Bognor Regis Golf Club

Full planning application the laying out of an 18 hole 72 par golf course, a 9 hole golf course, practice greens and a driving range, including a buggy compound; the formation of a new access onto the A259; the construction of a club house with associated golf club facilities; the construction of a maintenance building and external area of hardstanding; the laying of parking, new roads and paths; new landscape planting; surface water drainage basins and water storage reservoirs; and other earthworks and infrastructure - M/16/22/PL
Hallam Land Management Limited

TECHNICAL NOTE

DATE:	06 October 2022	CONFIDENTIALITY:	Public
SUBJECT:	WSP Response to EA Comments		
PROJECT:	Bognor Golf Course Hydraulic Model	AUTHOR:	Andy Smith

Annex 1 – Basin Mark Up

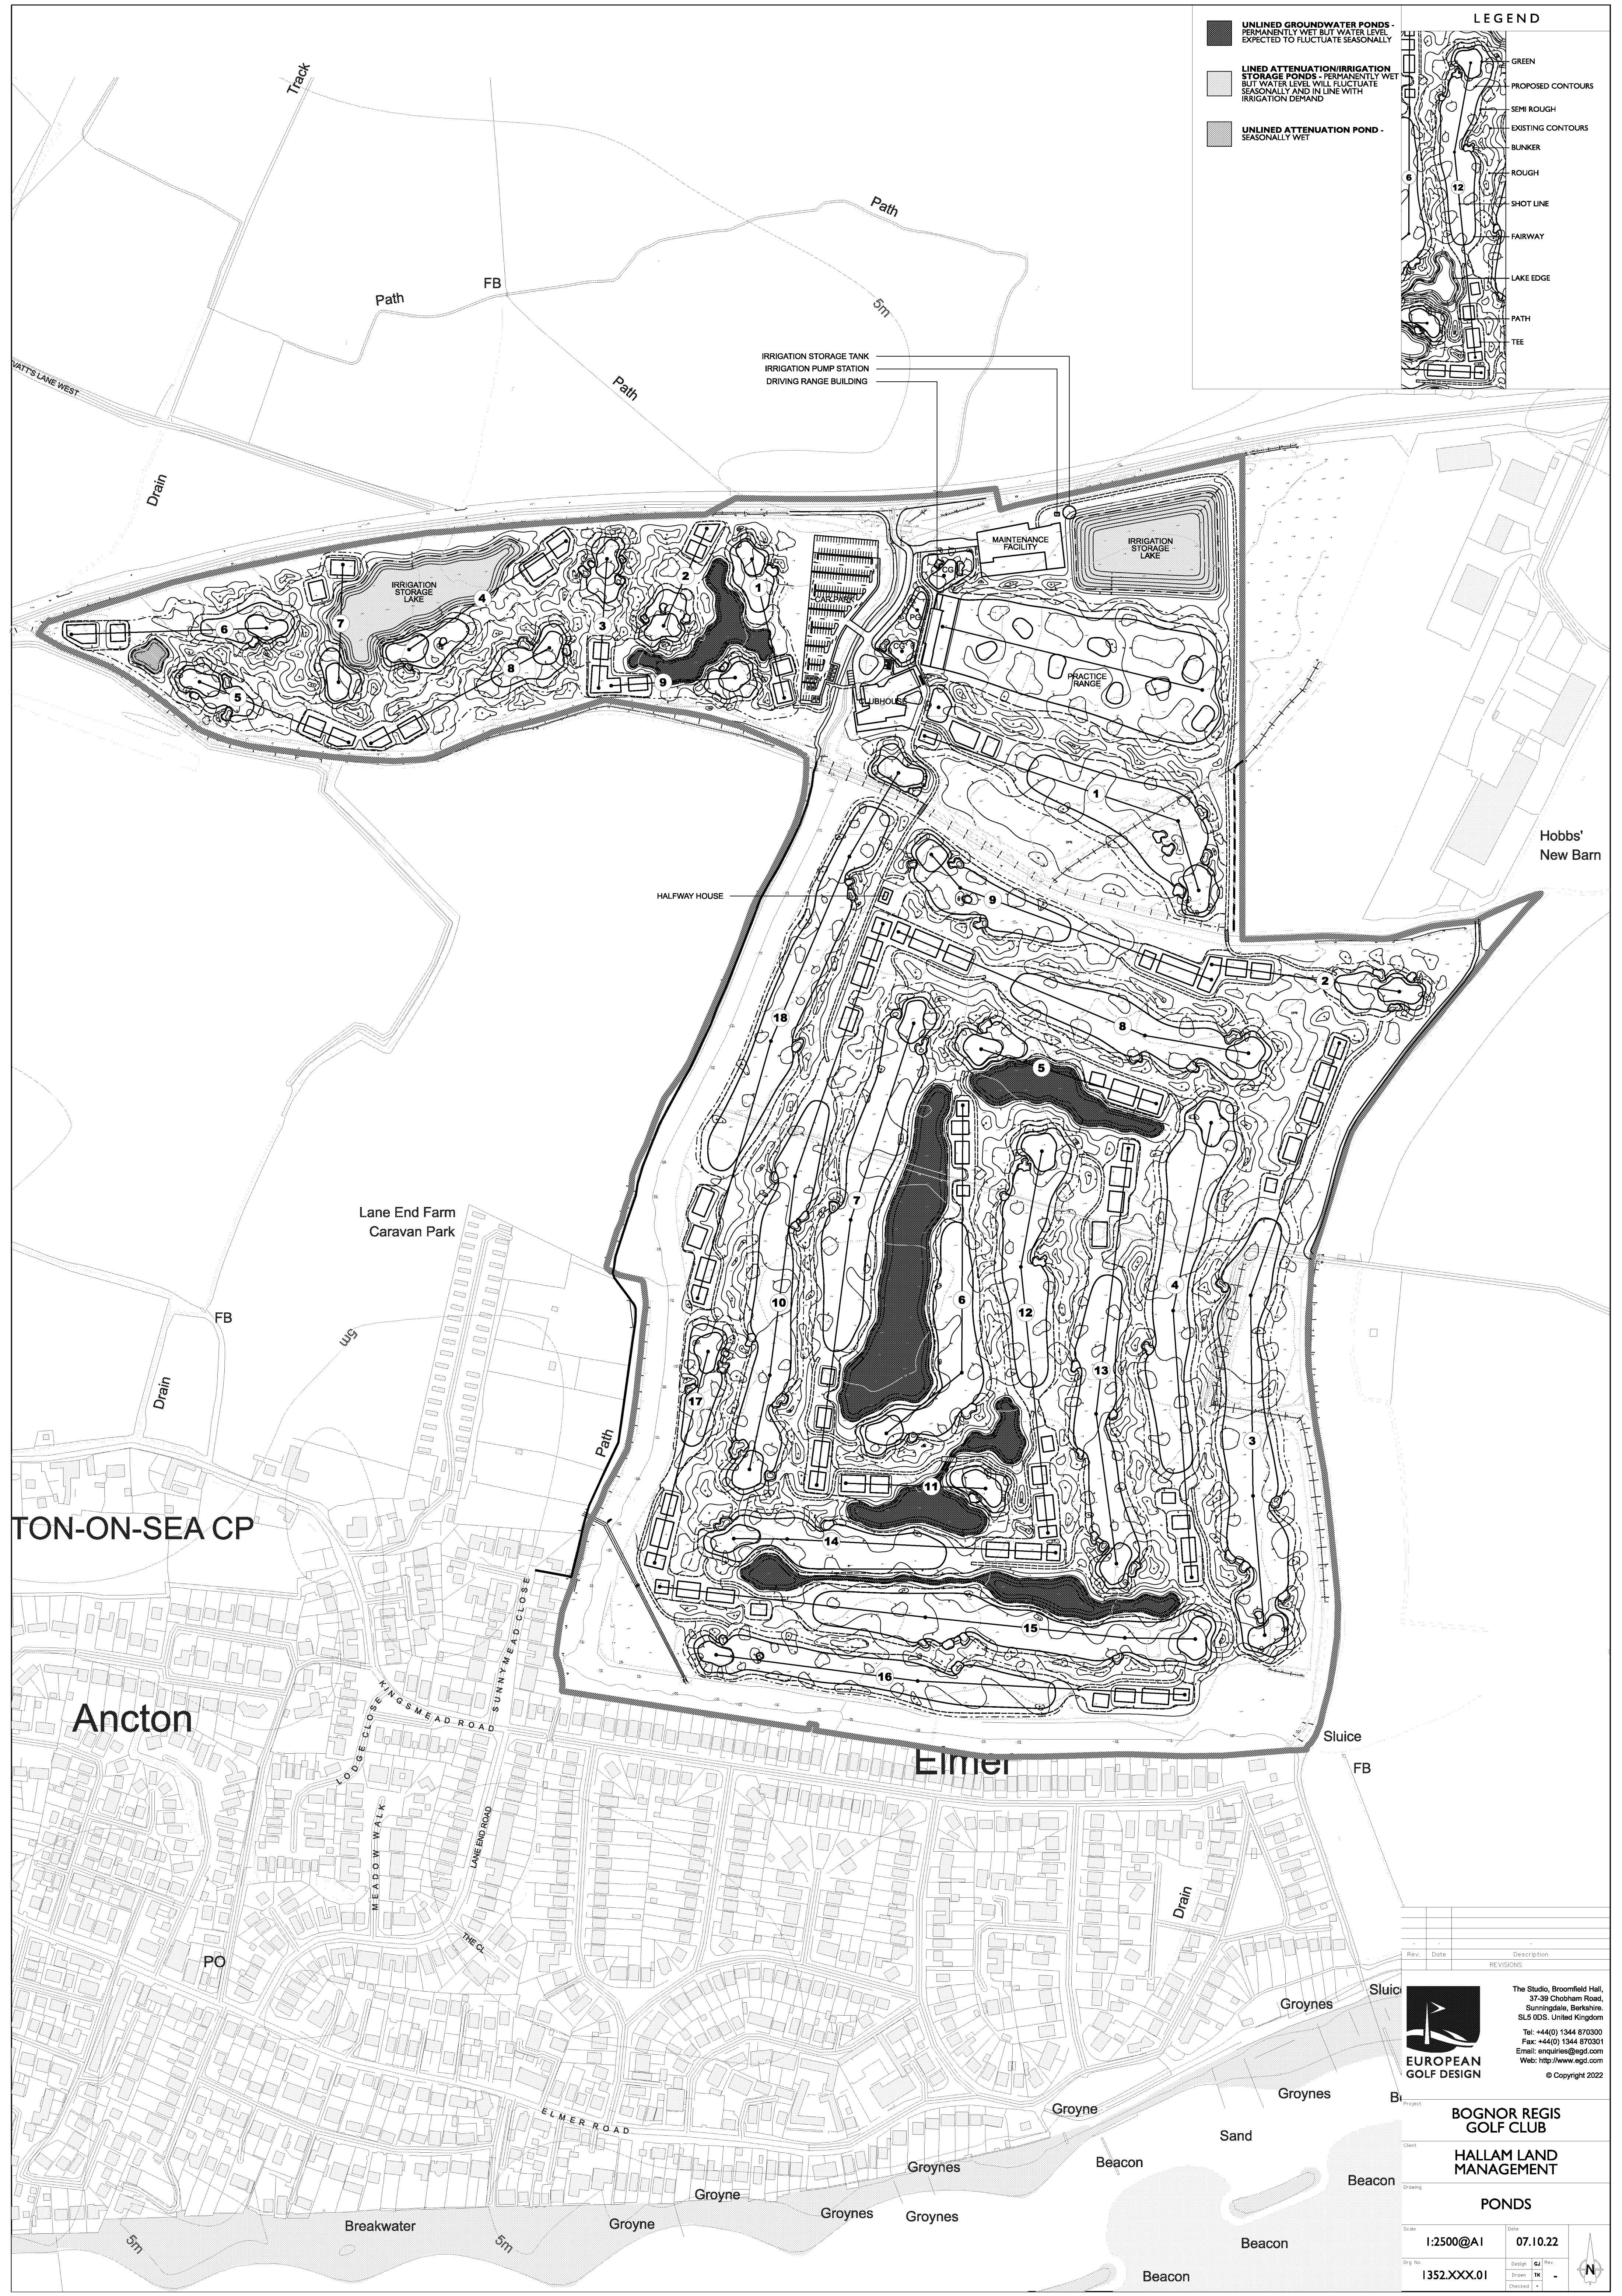
To clarify the query over whether the drainage basins will be wet or dry, a mark up has been prepared to set out which basins will be seasonally wet and which will retain water as a feature of the golf course. This is included at Annex 1.

UNLINED GROUNDWATER PONDS -
PERMANENTLY WET BUT WATER LEVEL
EXPECTED TO FLUCTUATE SEASONALLY

**LINED ATTENUATION/IRRIGATION
STORAGE PONDS - PERMANENTLY WET
BUT WATER LEVEL WILL FLUCTUATE
SEASONALLY AND IN LINE WITH
IRRIGATION DEMAND**

UNLINED ATTENUATION POND -
SEASONALLY WET

Table 1: 10.25hr 100yr Design Rainfall Depths

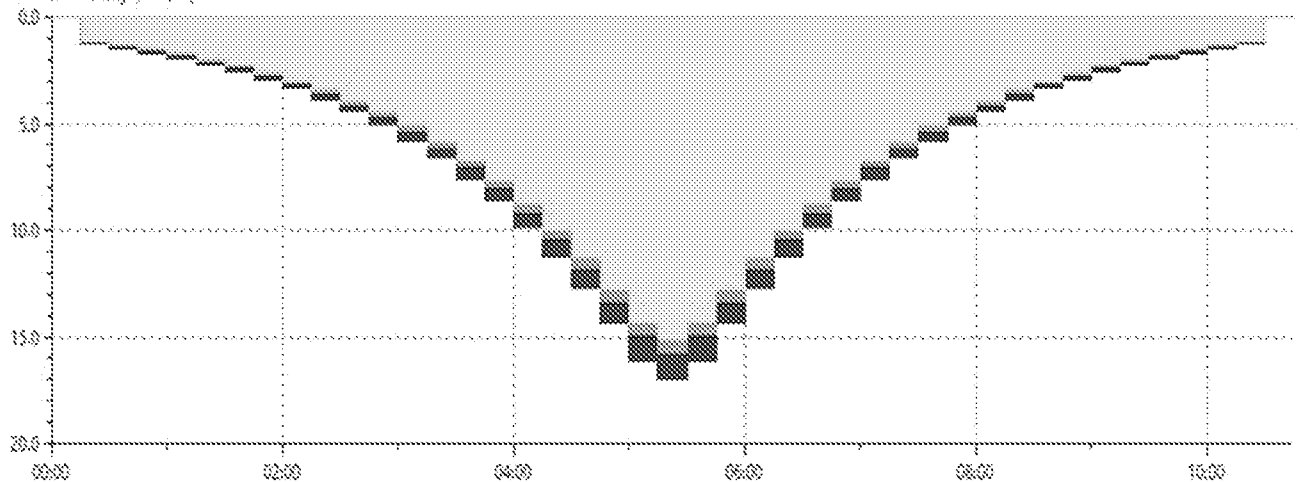
- 2. An example rainfall hyetograph has been included in the hydrology report (figure 4). In addition, a table is presented in table 4 which presents the revised rainfall depths. The rainfall hyetographs and depths presented in the hydrology report were compared against the rainfall data for the 100 year 10.25 hr mm/hr+25%CC scenario included within the Infoworks Model. There appear to be differences between the rainfall applied within the hydraulic model and the rainfall rate/depths reported within the hydrology report. Please clarify why there are differences.*

There are no differences between the rainfall within the hydraulic model and the rainfall reported within the hydrology report. The difference observed by the reviewer was caused by the data within the report being the current day scenario (i.e. no climate change allowance) and that within the model being for the future scenario (i.e. with climate change) for ease of approval the table has been updated below and the extract from the model provided by the Environment Agency reviewer is also below, noting that in the image the rainfall depths are presented in the reverse order than those in the table.

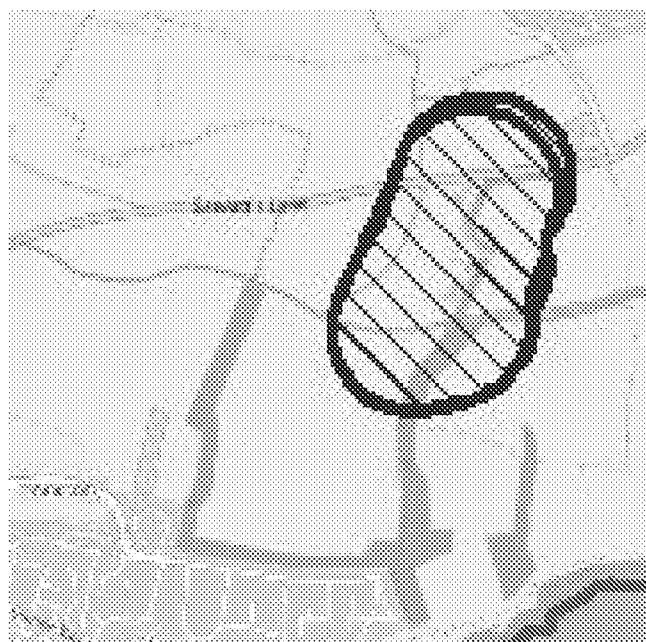
On the 13th September 2022 the Waste Officer responded to the application and requested a Waste Infrastructure Statement, to enable them to assess the compatibility of the proposed golf course with the existing waste infrastructure at Hobbs Barn.

Currently, the distance between the waste site and the far eastern boundary of the site is approximately 126 meters. There is an identified buffer of 250m around this Waste site. An extract from the consultation zone is included below.

This plan demonstrates that the site is within the waste infrastructure consultation zone and for this reason this Waste Infrastructure Statement has been prepared.
